Strathcona Gardens Rec-Reate Aquatic Centre & Renovations **ADDENDUM #4**

Date: March 28, 2024

ARCHITECTURAL TENDER ADDENDUM #4

This addendum revises the Tender Documents for Strathcona Gardens REC-REATE issued for tender February 2, 2024.

1 : 200

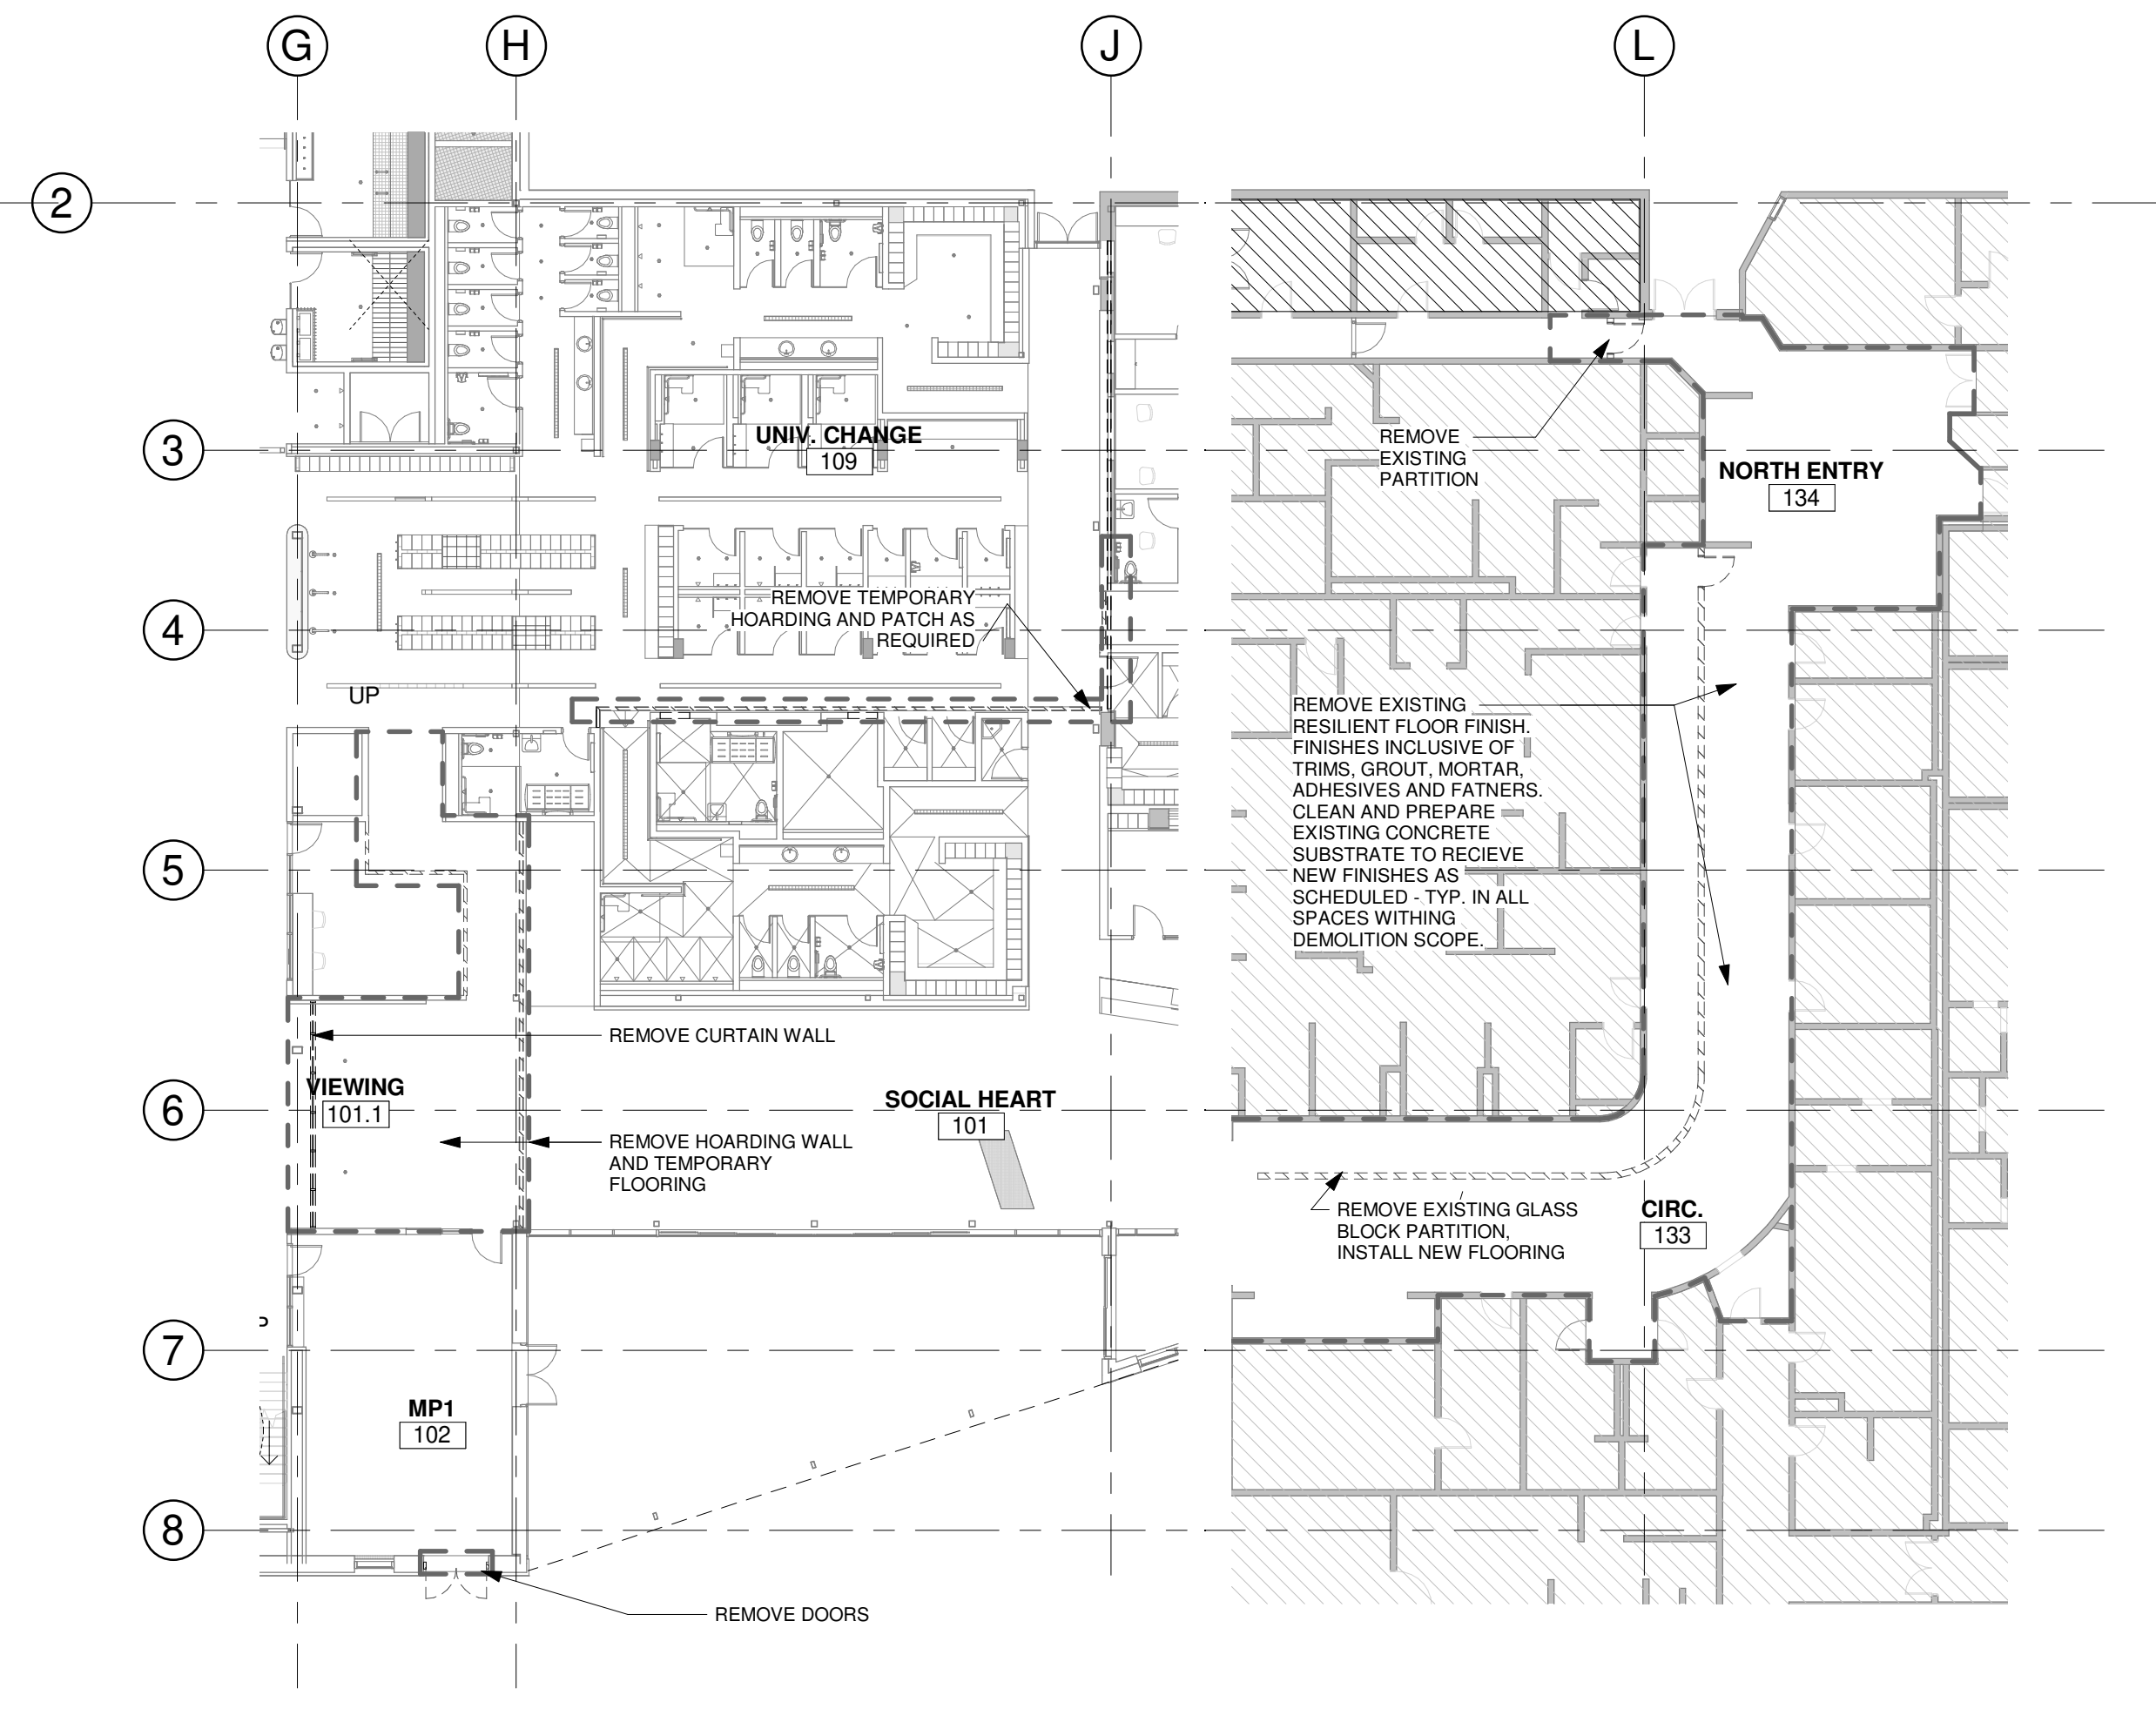
1. REVISE: A203/2 demolition note to include the removal of the existing wood wall system.

1 FLOOR PLAN - BASEMENT
1 : 100

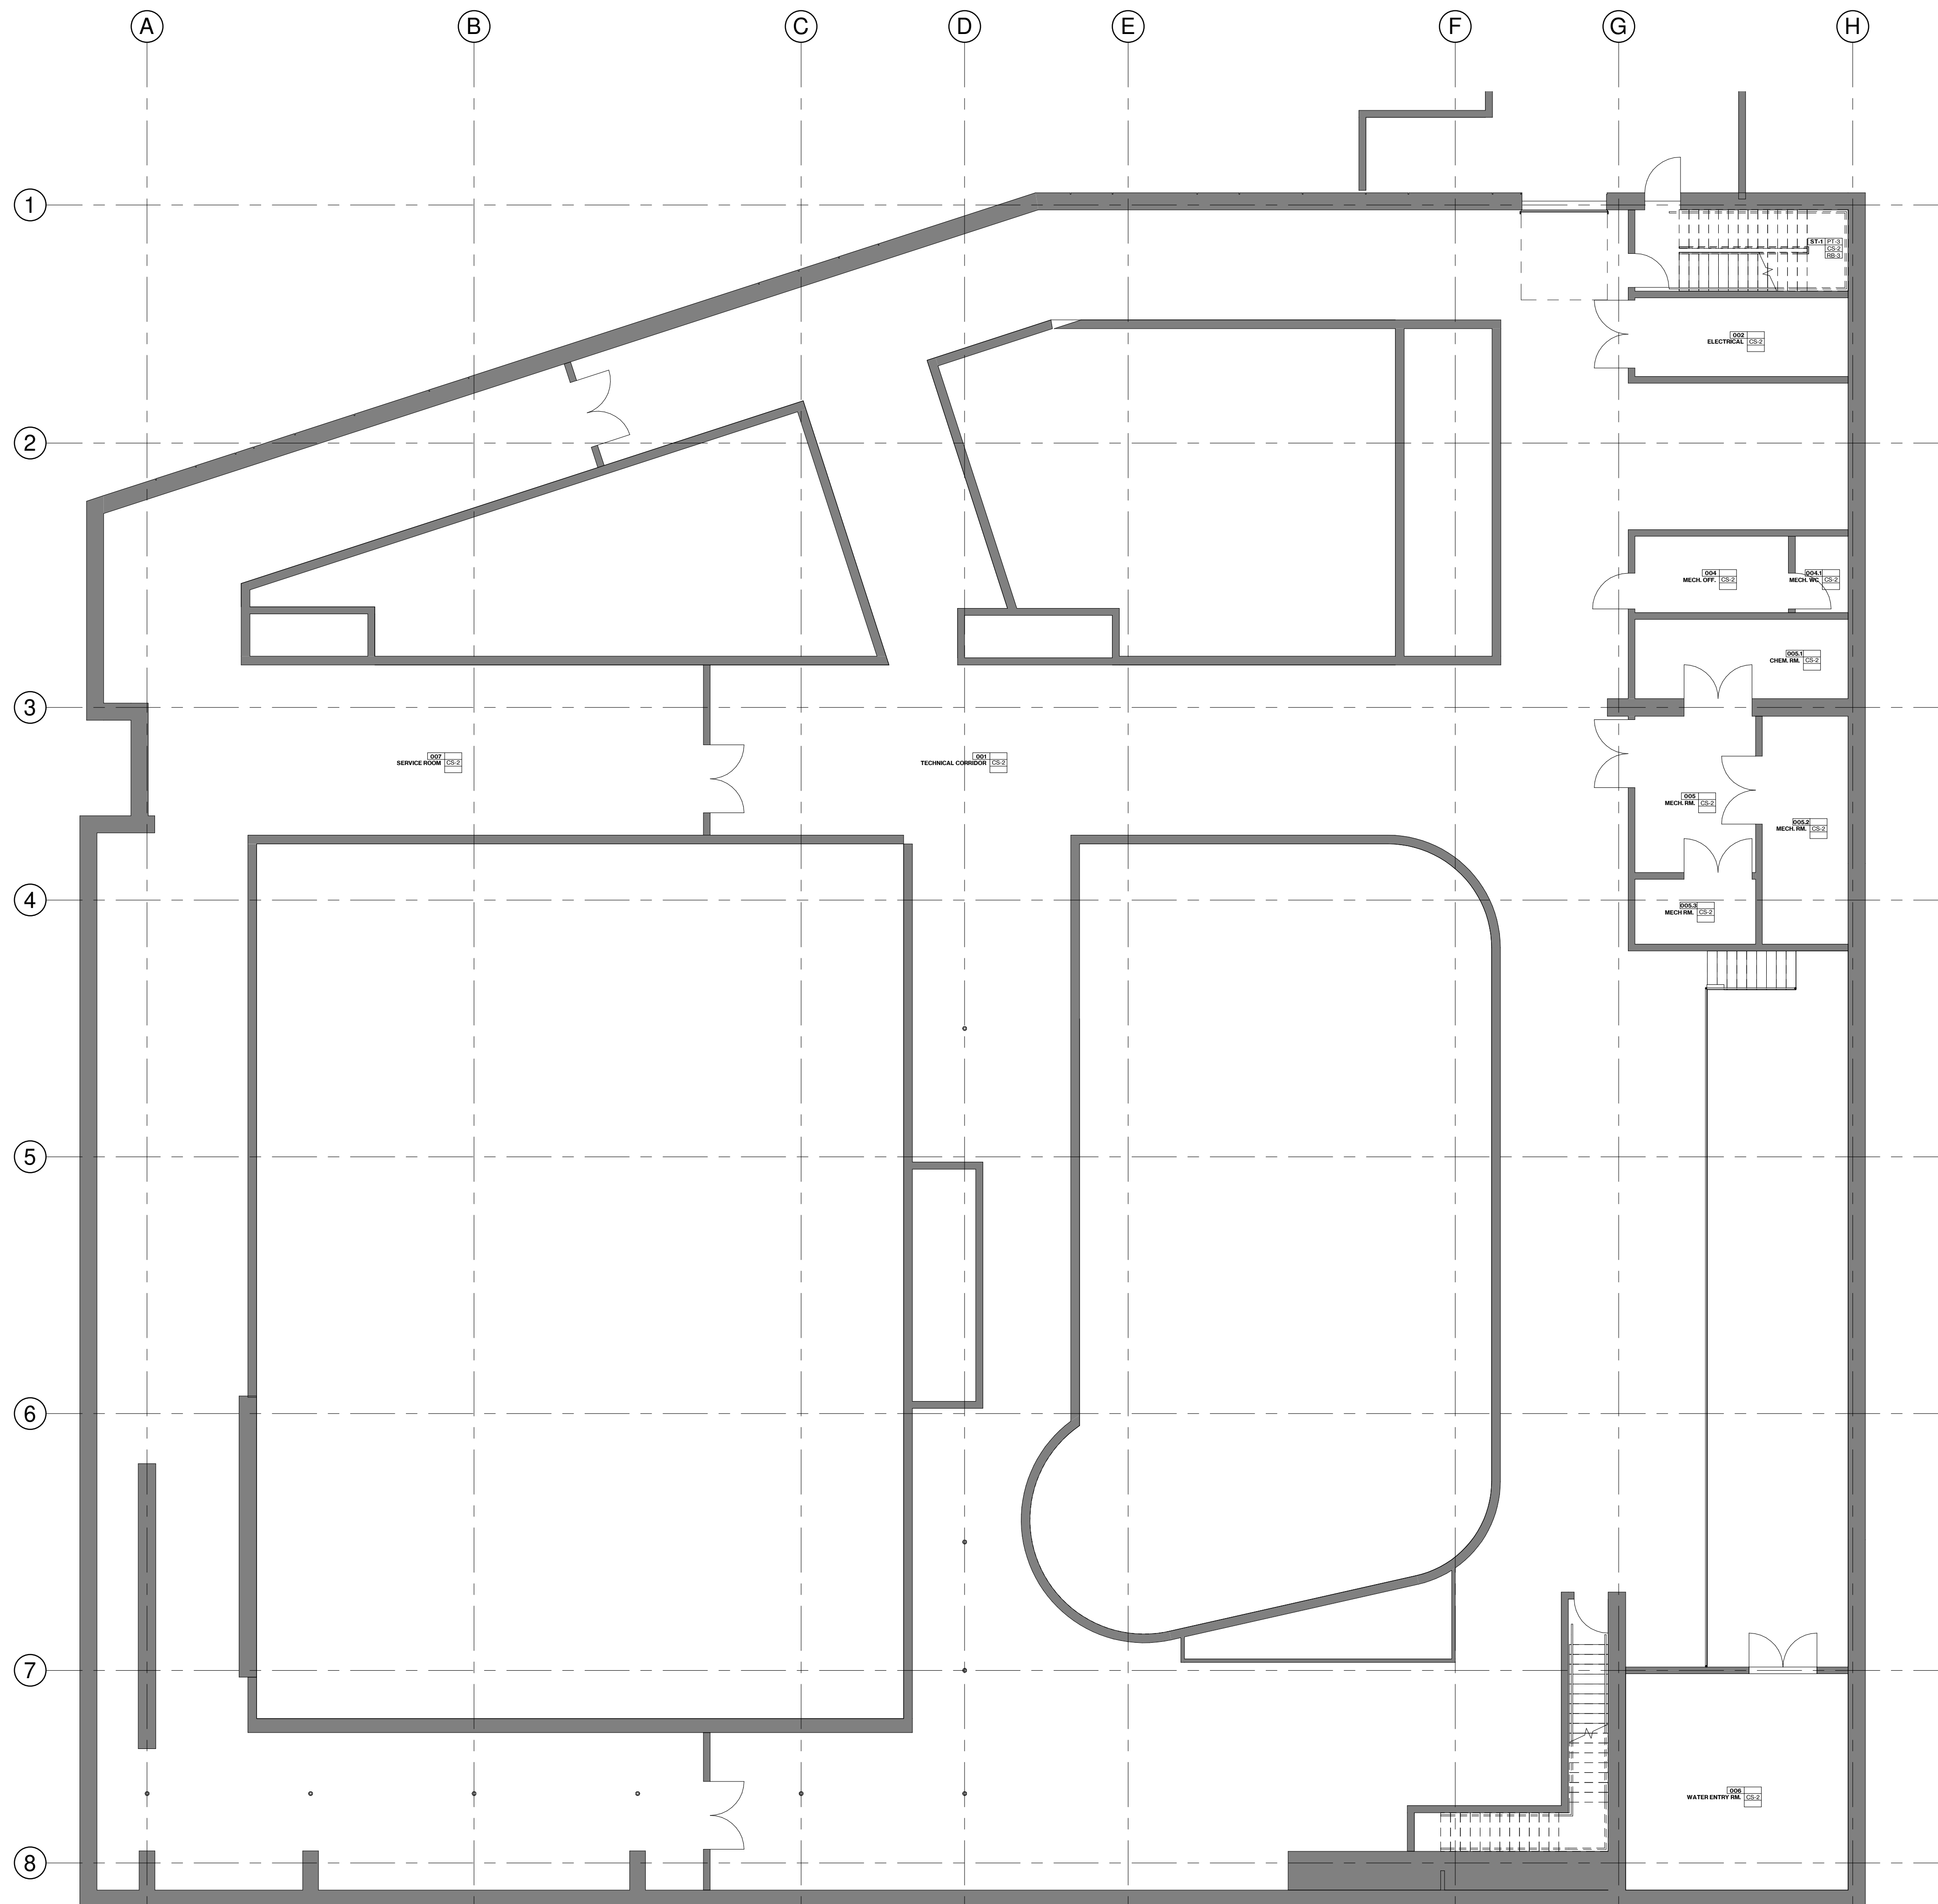
1. ADD: New drawing describing P1 Basement floor finishes.

1 FLOOR PLAN - CHANGEROOMS ENLARGED PHASE 2
1 : 50

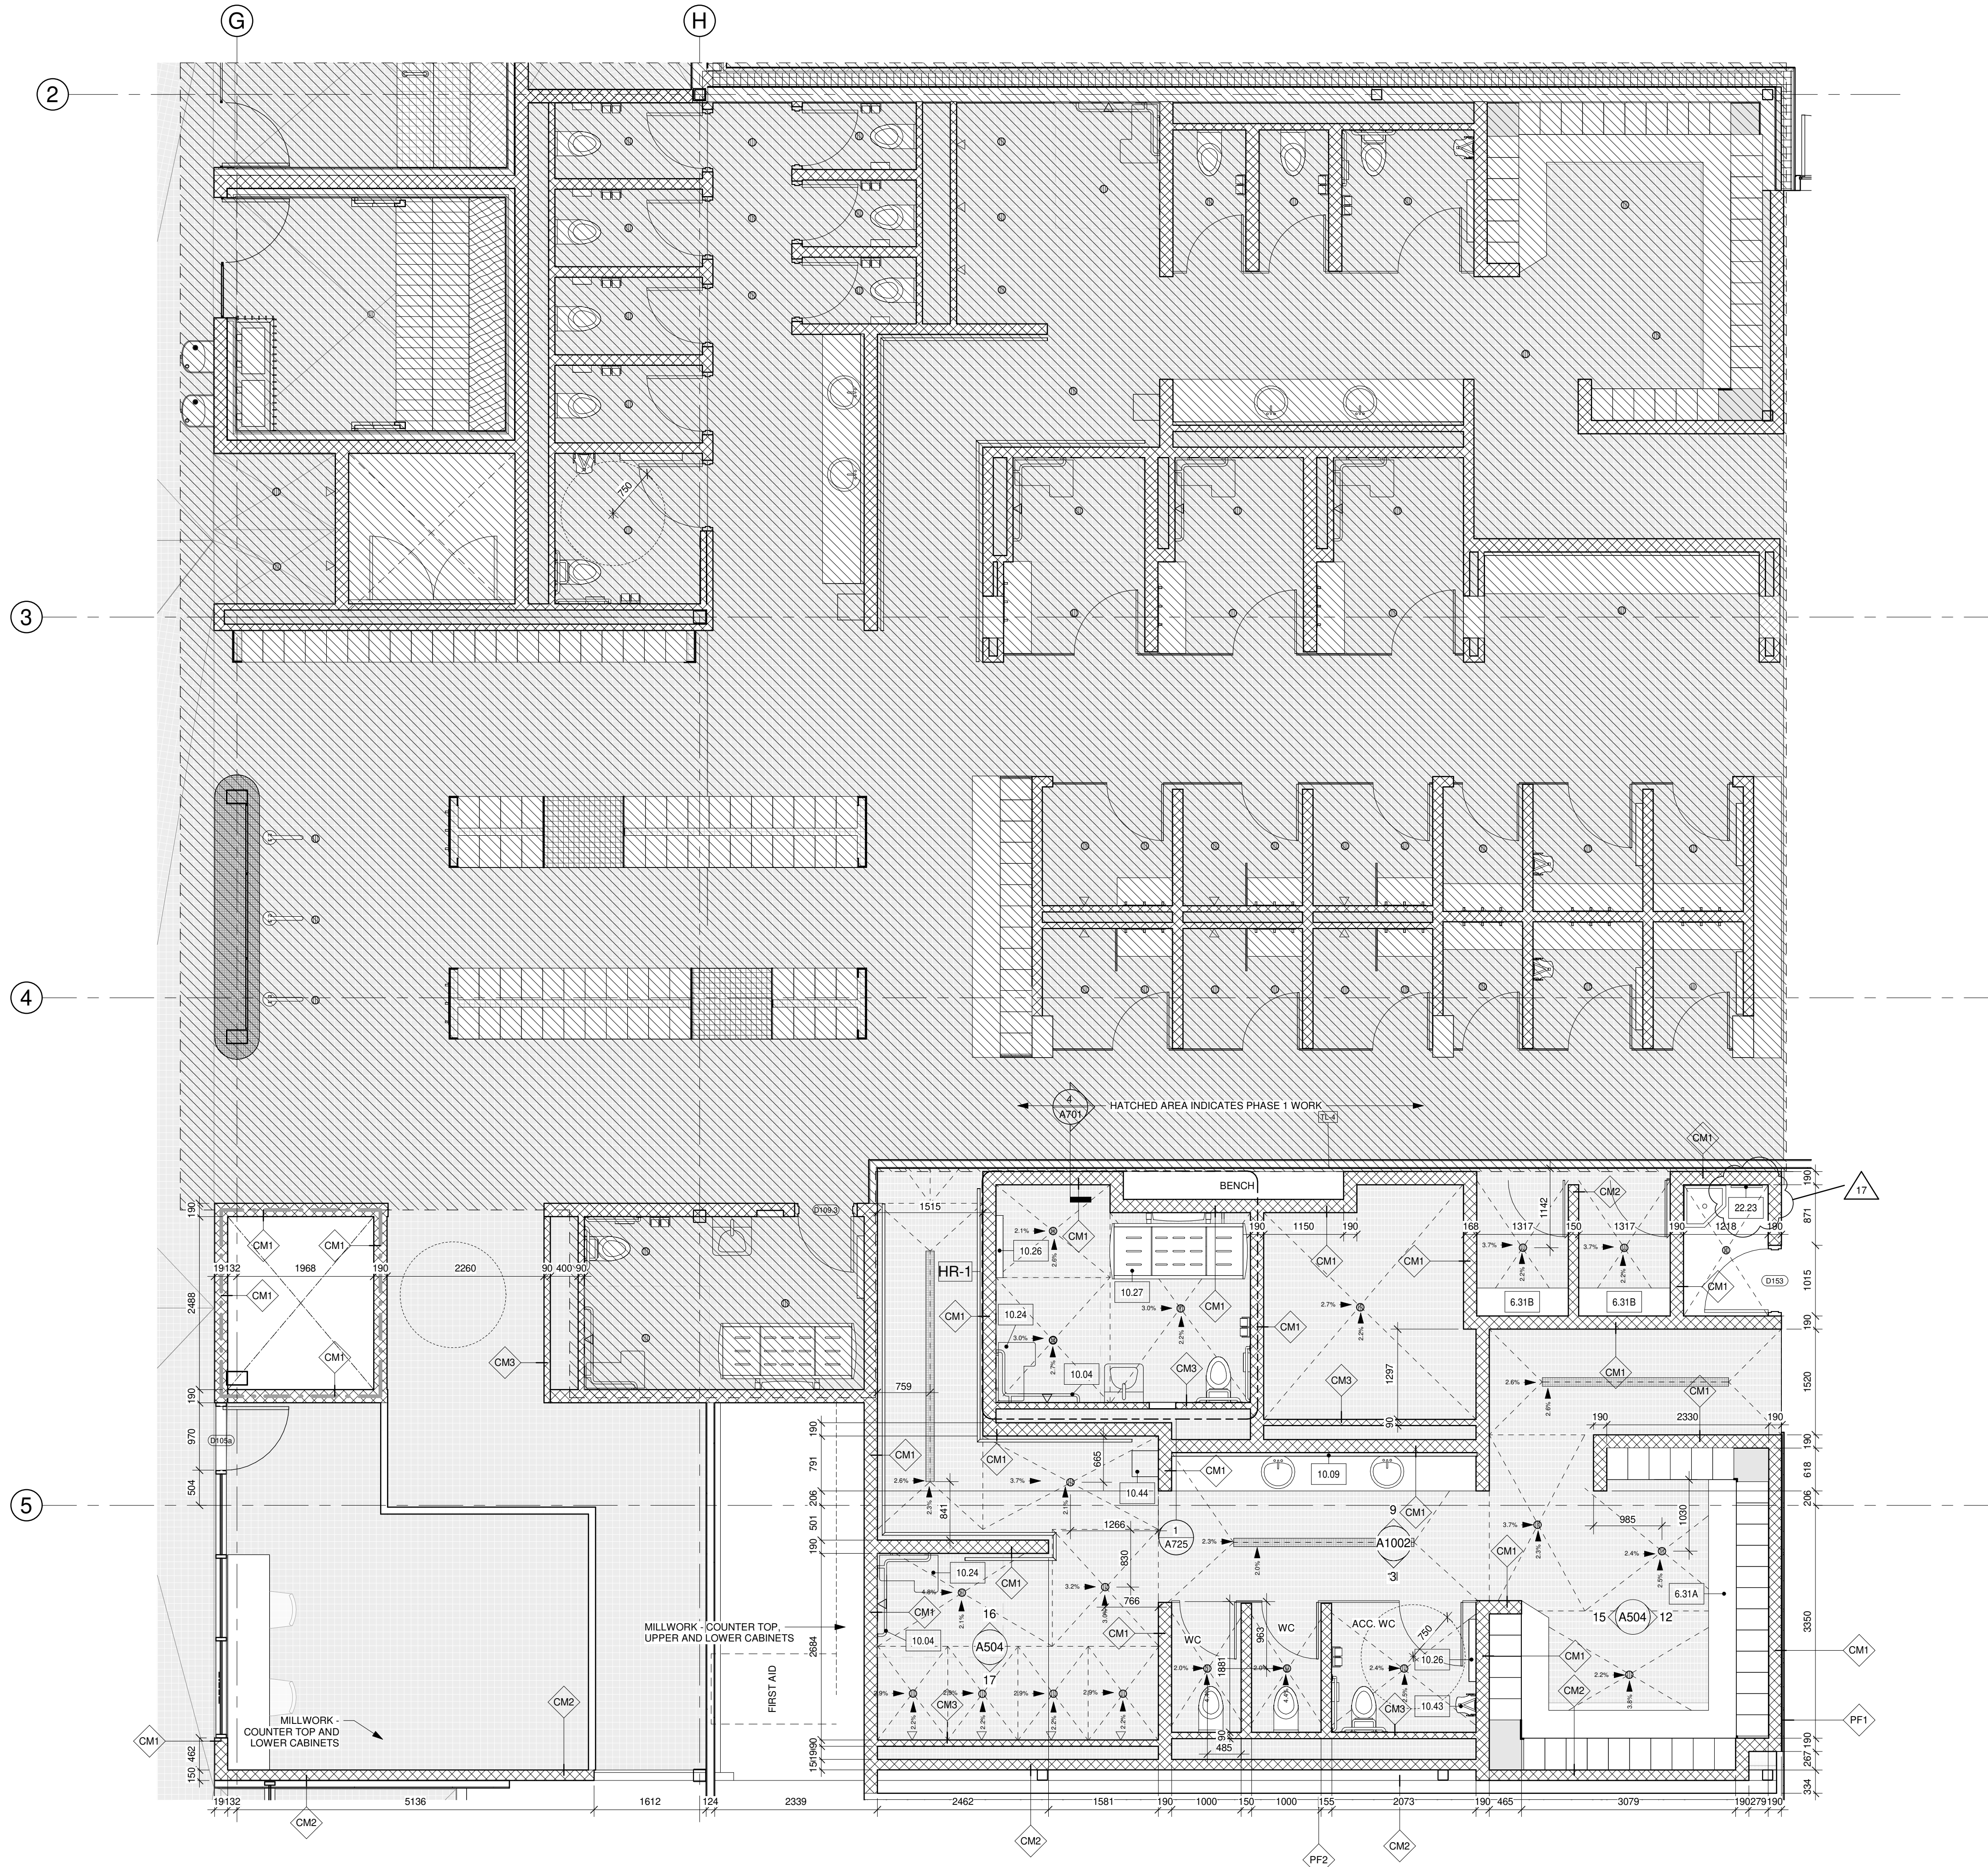
1. ADD: Mop holder in Janitor room
2. ADD: Keynote Legend
